REQUEST FOR INFORMATION DATE: January 30, 2017 NO.: RFI-432

Project Name: 15051-Webster University Interdisciplinary Science Building Project No.: 15051

Subject: Undercabinet light in room 289B

L02 TISSUE CULTURE - NORTH

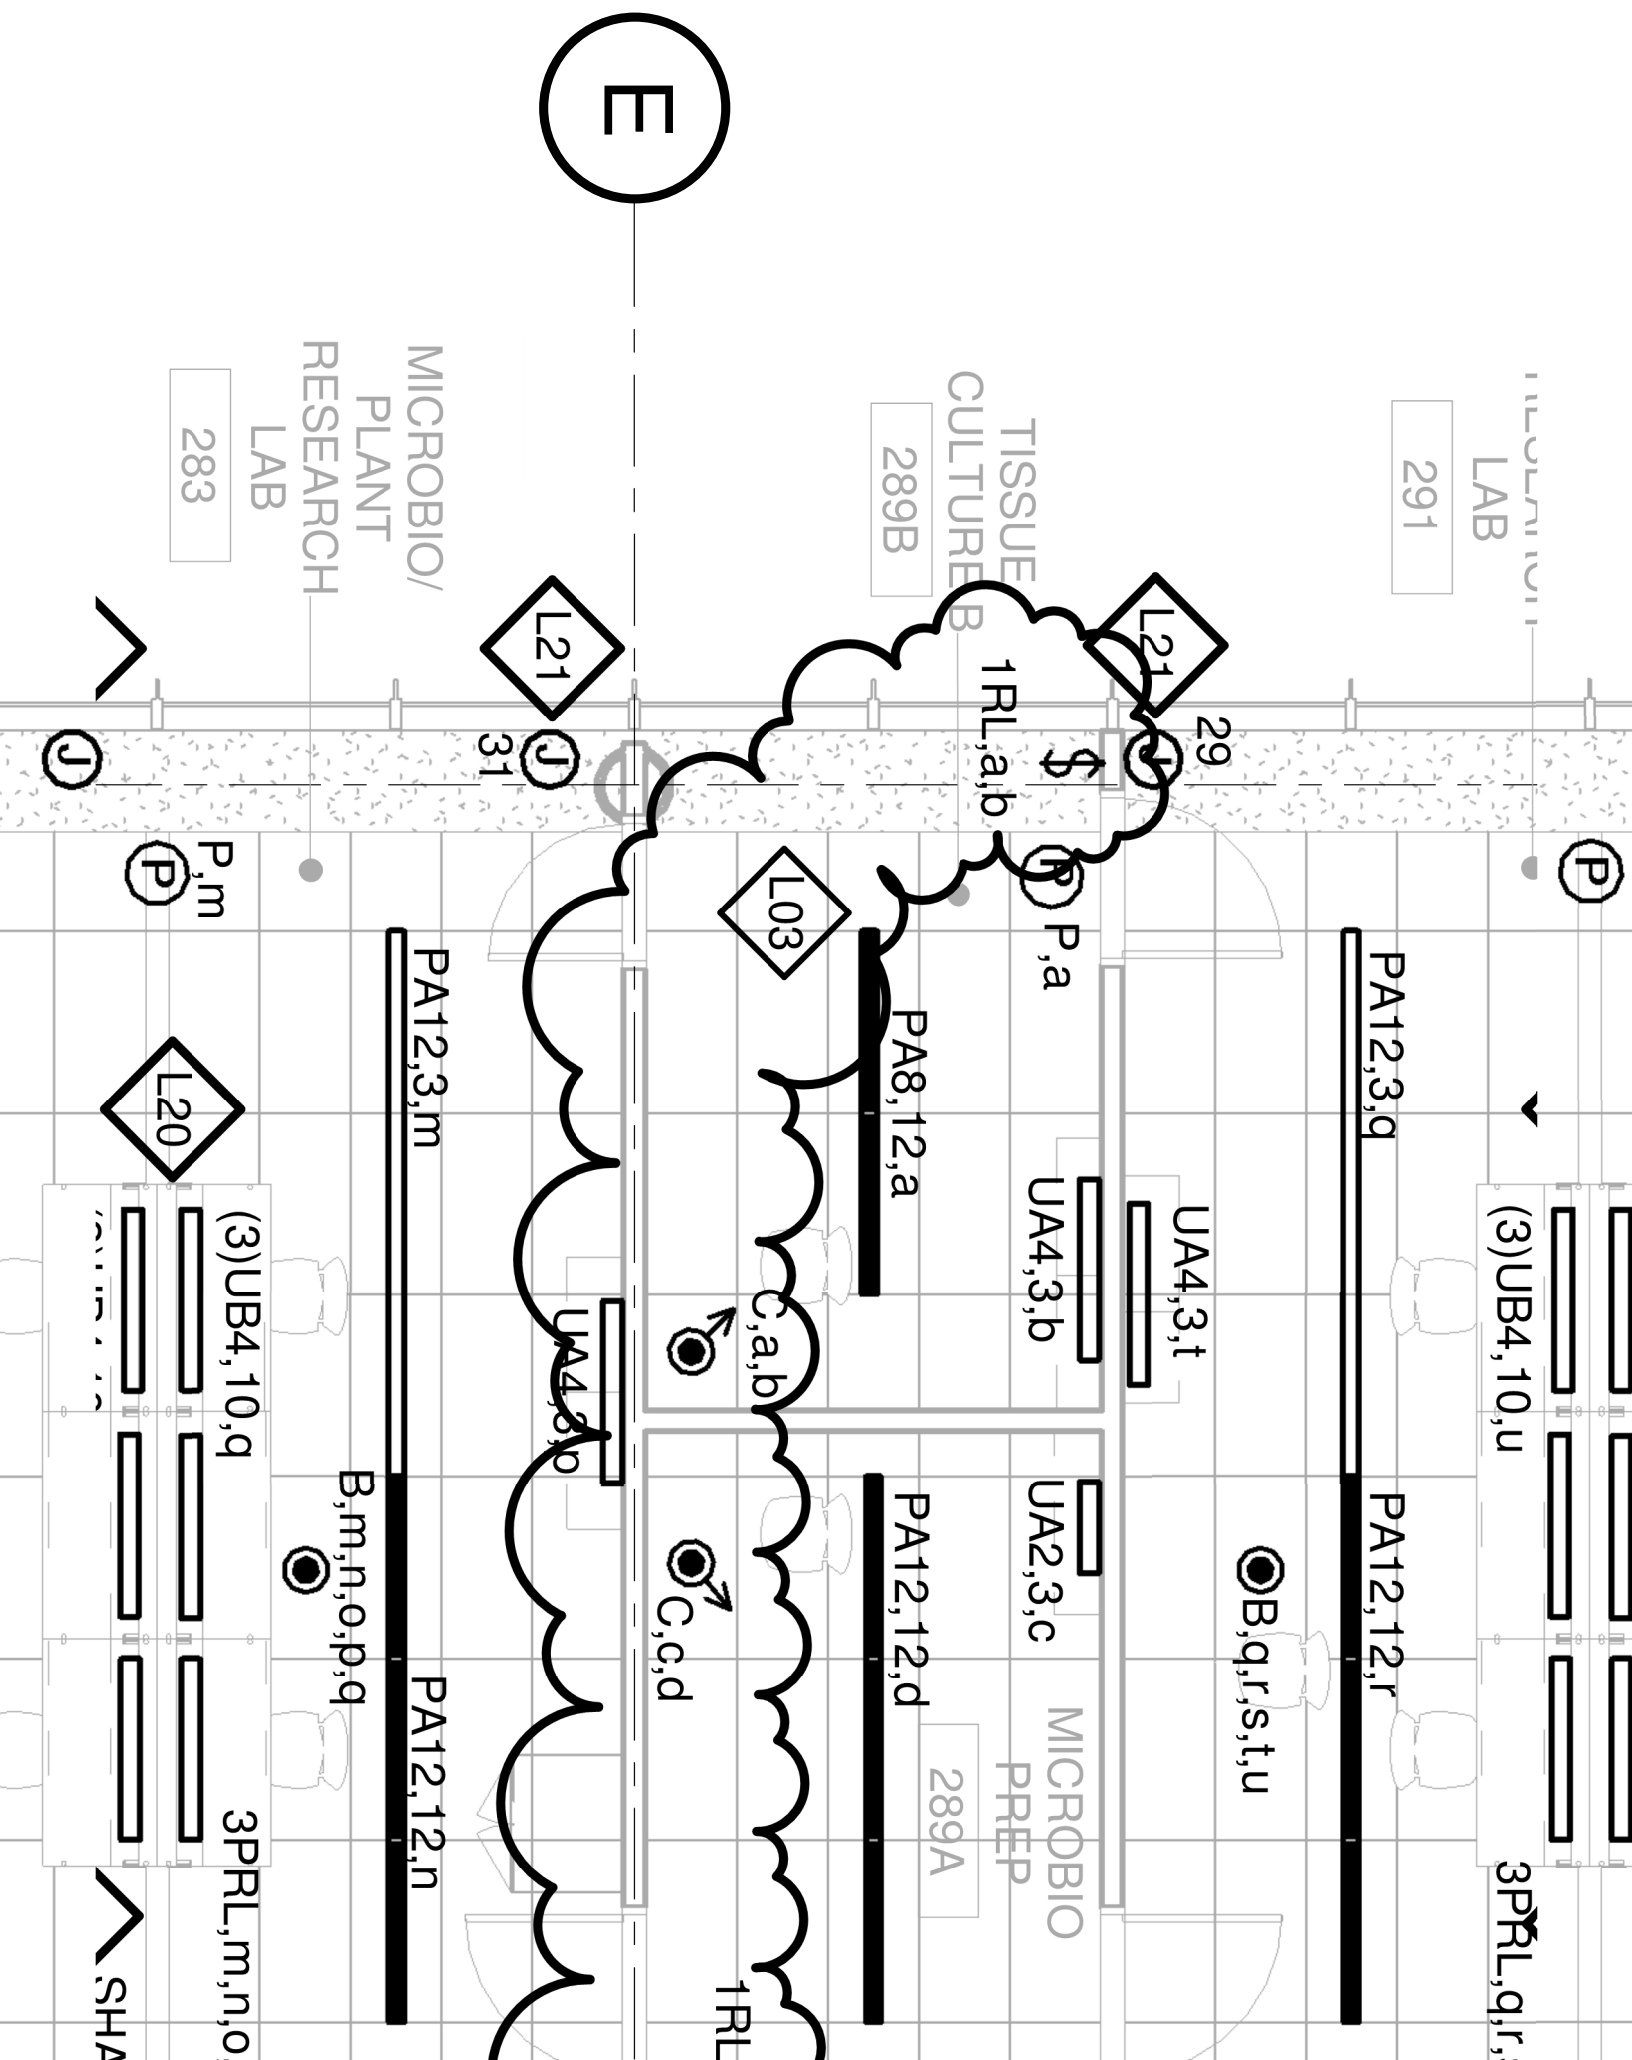
E0202.A calls for a UA4 4' undercabinet light in room 289B. Room 289B has adjustable shelves with vertical supports 3' apart. Please advise if this should be changed to two smaller lights in lieu of the 4' light.

Please provide vertical and horizontal light location.

Refer to ASI-049. Provide two Type UB2 fixtures in-lieu of one UA4 fixture. Fixtures will be magnetically mounted to the underside of the adjustable shelves. The associated power supply will plug into the raceway currently shown to serve counter. Attach power supply to shelf vertical support to keep it out of the way. Ensure the daisy chain cable is long enough (2' long recommended) to allow for reasonable shelf adjustment.
